35/13-04P 6 Primrose Street
Chevy Chase Historic District

SUBJECT: Historic Area Work Permit # 342572 and 34366

HISTORIC PRESERVATION COMMISSION STAFF REPORT

PROPOSAL: Fence, driveway, and retaining wall alterations

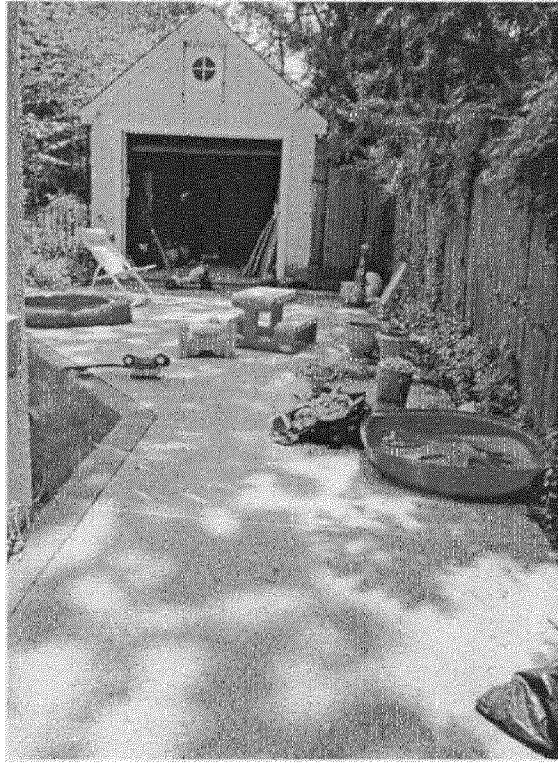
driveway to be removed, stone wall to be extended

concrete section to be removed

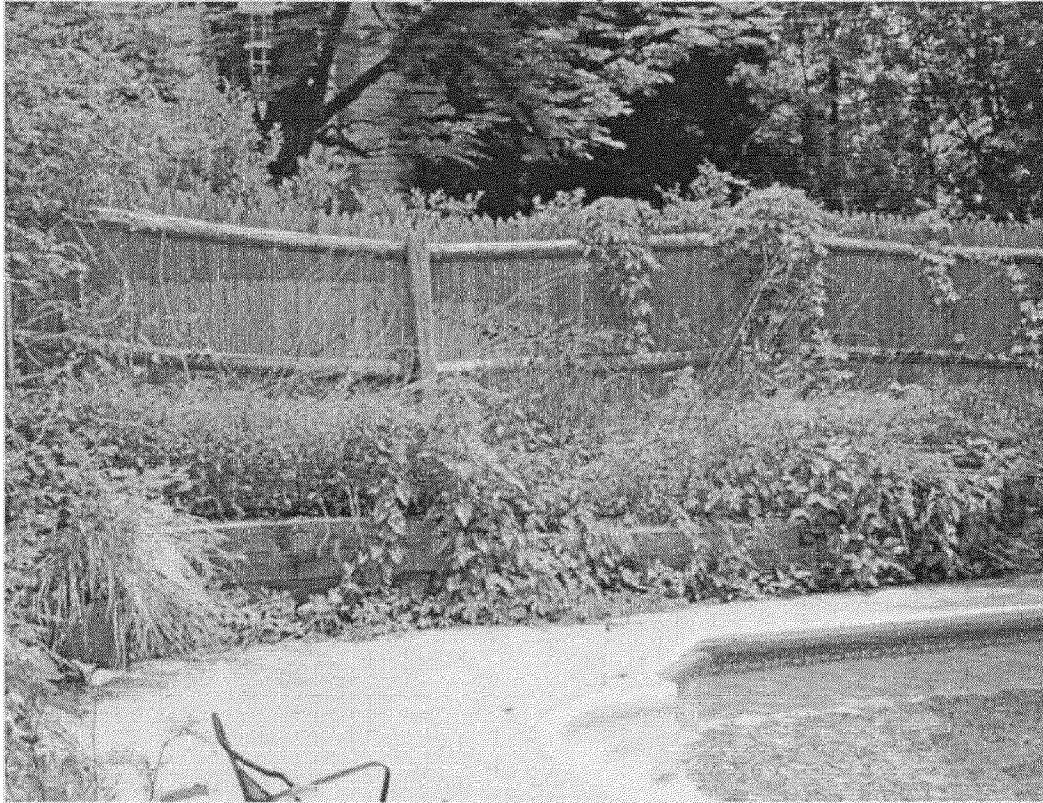
ex. fence to be replaced with 5' high wood fence to meet Code for pool

timber retaining wall to be replaced with stone

ex. fence to be replaced with wood picket fence
